Re: Petition No. Petition 1201 - GHCC 1810 Line Project

Response to CSC-01 Interrogatories dated 12/16/2015
CSC-001, 002, 003, 004, 005

**1810 TRANSMISSION LINE
 POTENTIAL VERNAL POOLS**
 EVERSOURCE ENERGY
 LINE 1810

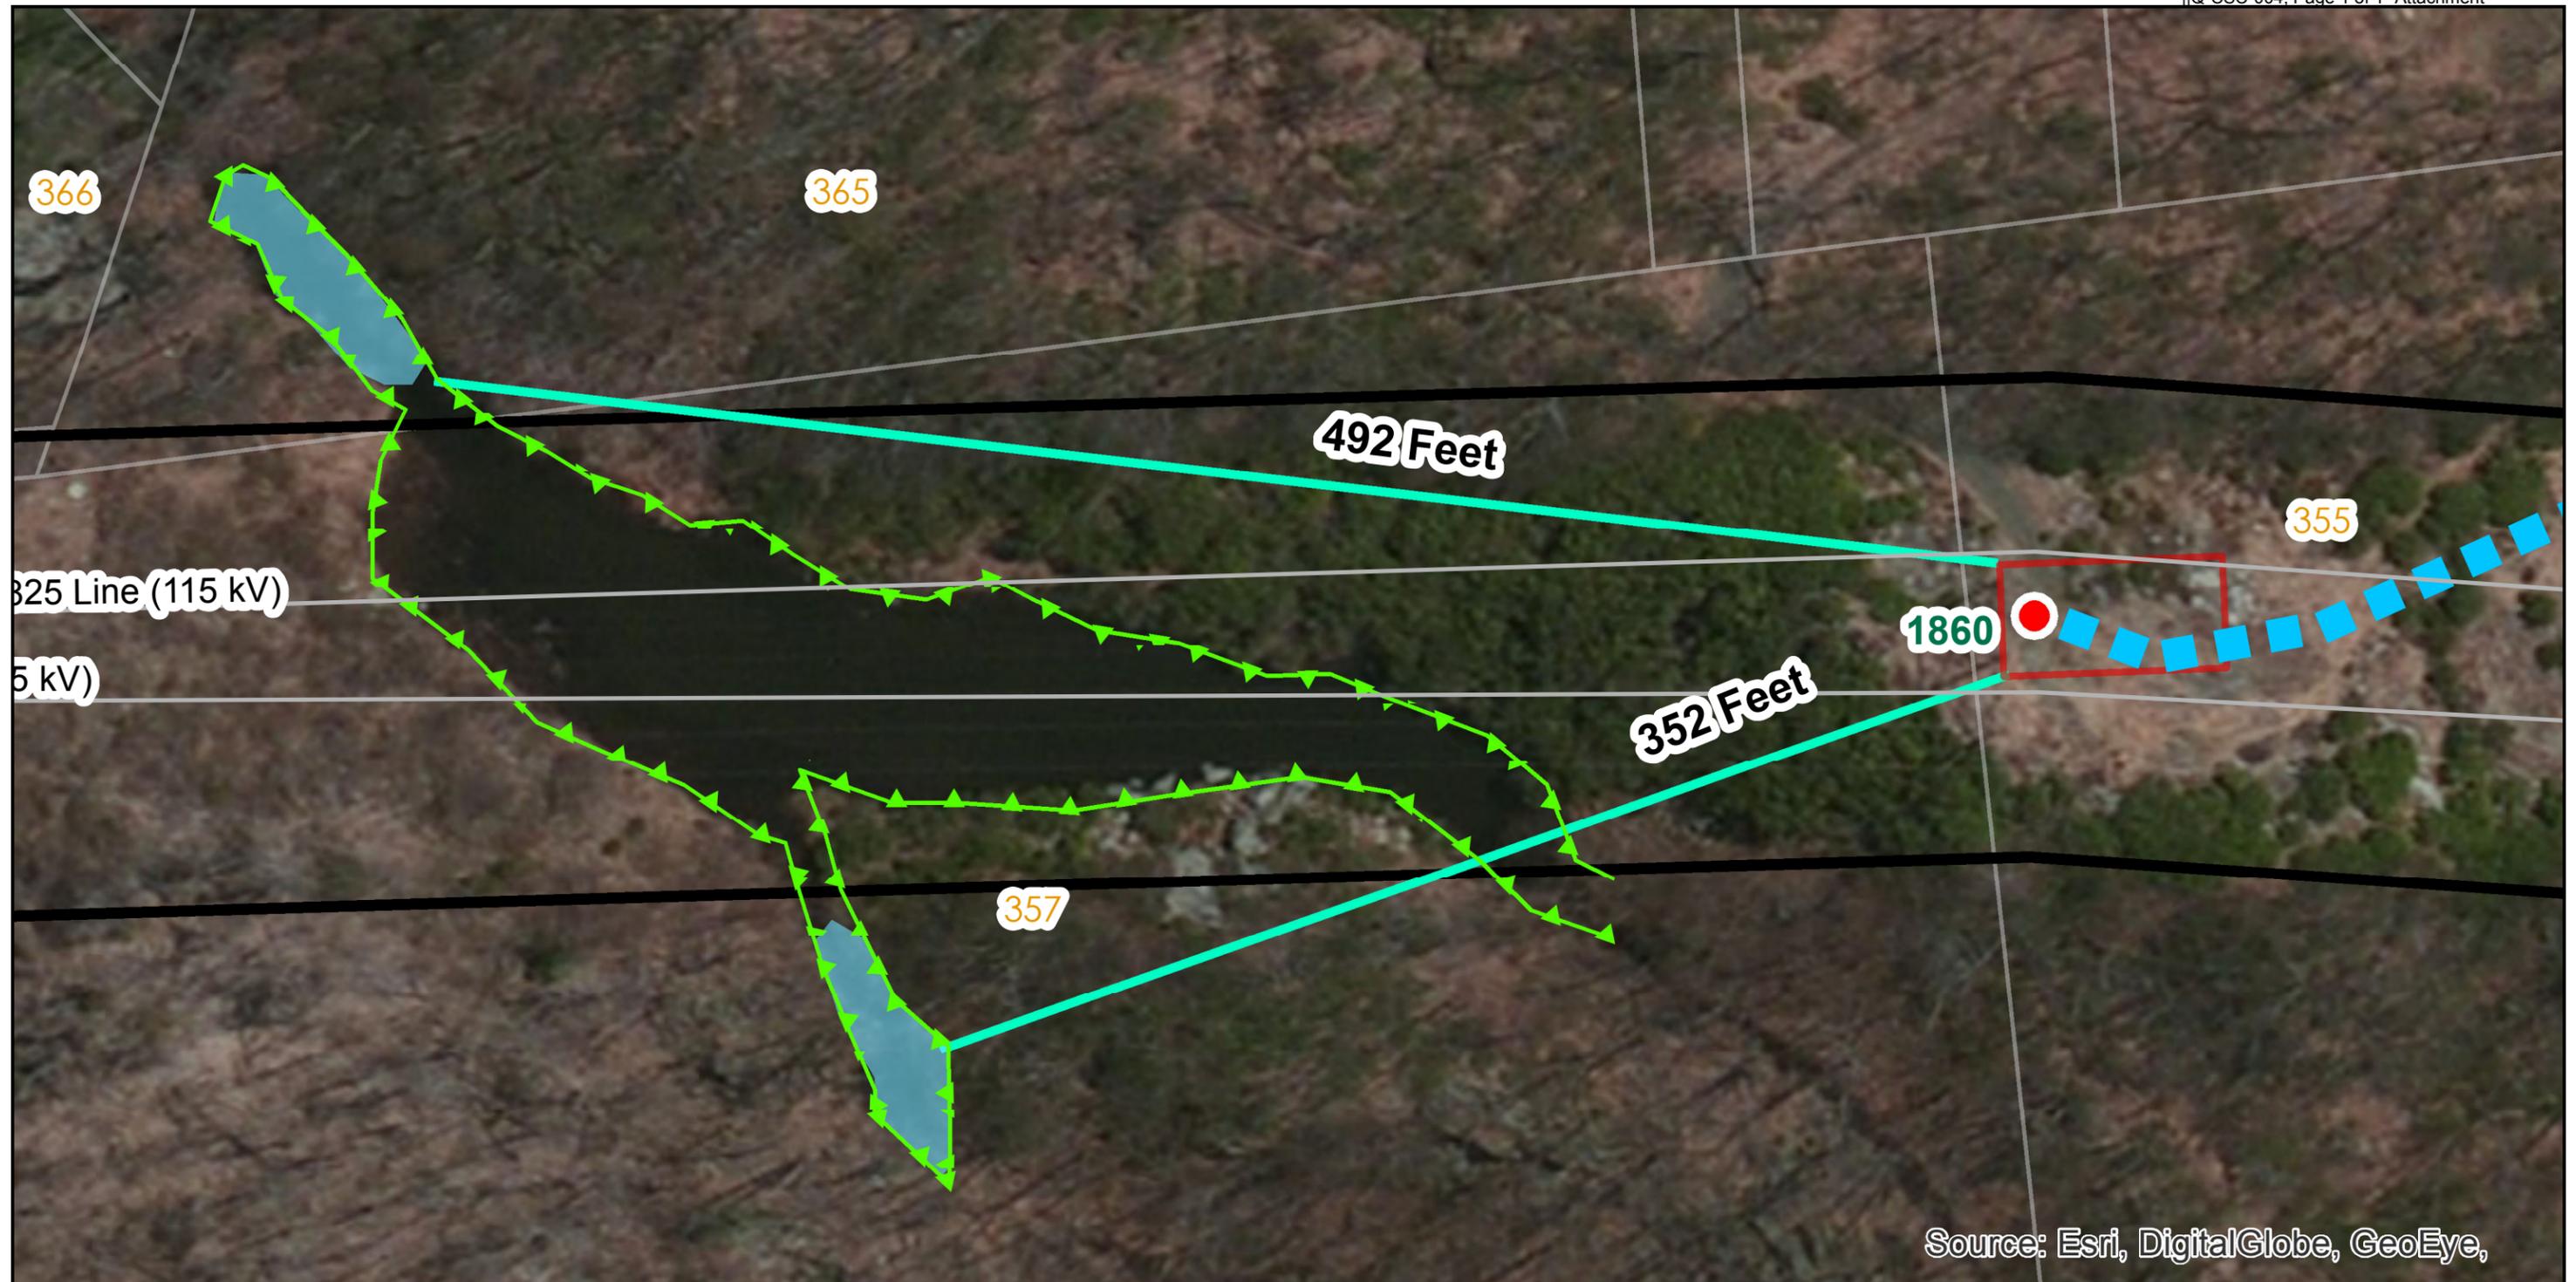
Under Attachment B of the Petition, Sheet 1 indicates that two potential vernal pools are located approximately 350 feet and 500 feet, respectively, from structure #1860. Depict the approximate locations of the potential vernal pools relative to structure #1860 on a drawing.

Attached is the depiction of the approximate locations of the potential vernal pools relative to structure #1860.

Timber mat bridge.

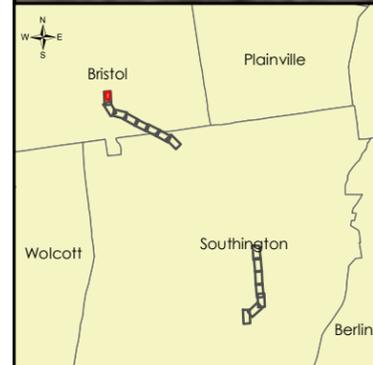
On Sheet 10, would the proposed 18-foot wide bridge to cross Wetland 12 be permanent?

No, the wetland will be crossed using appropriate temporary crossing techniques as detailed in the Eversource Best Management Practices Manual: Connecticut (page 3-31 *Bridged Crossings: Swamp Mats as Temporary Bridge*).
